RECORD OF DECISION AMENDMENT

**NORTH PENN AREA 5
SUPERFUND SITE
Operable Unit 1
Montgomery County, Pennsylvania**

**U.S. ENVIRONMENTAL PROTECTION AGENCY
REGION III, PHILADELPHIA, PENNSYLVANIA
July 2016**

RS Figure 1. 1,1-DCE and TCE Concentrations Trends at PW-9B

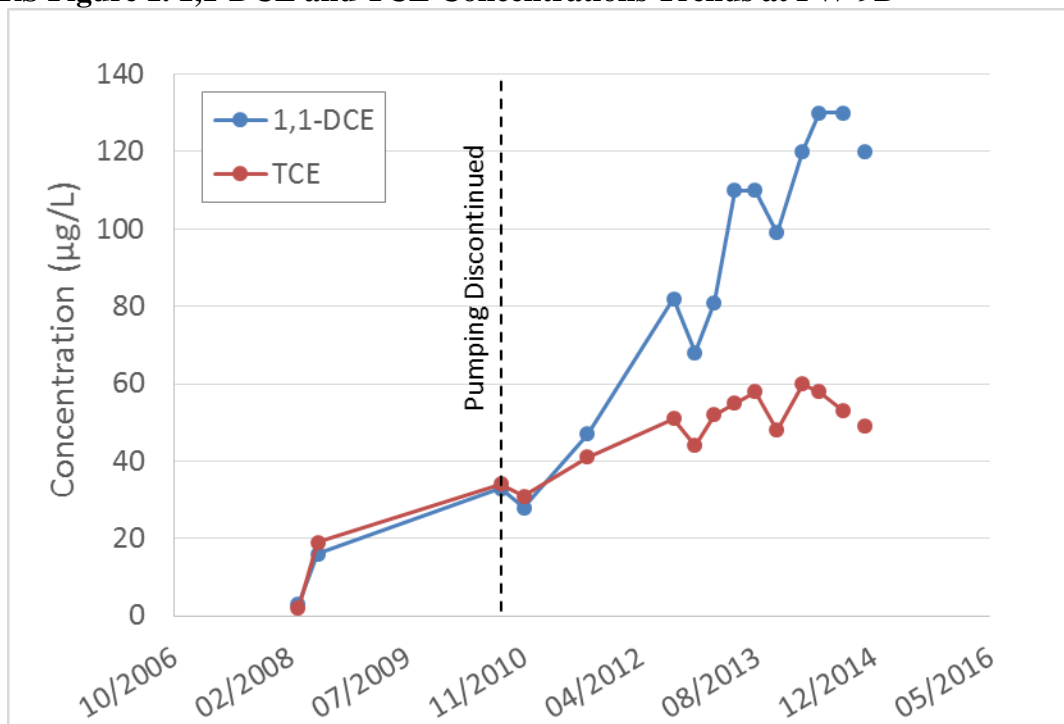
3.1.5 EA Comment 5: “The mass removal rate of the former pump and treat system was already maximized and demonstrates the limited effectiveness of this remedial option.”

EPA Response: BAE’s historic pumping has not been operational since August 2010 and, prior to that time, was not optimally designed for mass removal and source control. Hydraulic testing conducted by Environmental Alliance during the PDI demonstrated that some of the most contaminated wells at OU1 had a weak hydraulic connection with the extraction wells associated with historic pumping. For example, as part of the PDI, wells RW-1 and the Recovery Well were re-started in March 2008, but showed little or no hydraulic response in well PW-10A.

In contrast to well MW-5, contaminant concentrations at PW-9B increased when groundwater pumping was discontinued in 2010. RS Figure 1 (below) shows the TCE and 1,1-DCE concentrations at PW-9B from February 2008 until December 2014. When pumping was discontinued, concentrations of TCE and 1,1-DCE increased at PW-9B, which suggests that groundwater extraction, if effectively designed, can reduce plume concentrations and facilitate restoration of the aquifer. It is not clear, based on the available data, which extraction well most impacted the concentrations at PW-9B, but the system restart test suggests that, of the three extraction wells, RI-20S likely has the strongest hydraulic connection with PW-9B. RI-20S generally operated at less than 1 gallon per minute (gpm) from 2004 through September 2009 and only increased to an average of 3 gpm in 2010 before being shut down in August 2010. PW-9B was first sampled in 2008 and sampling was limited between 2008 and 2010.
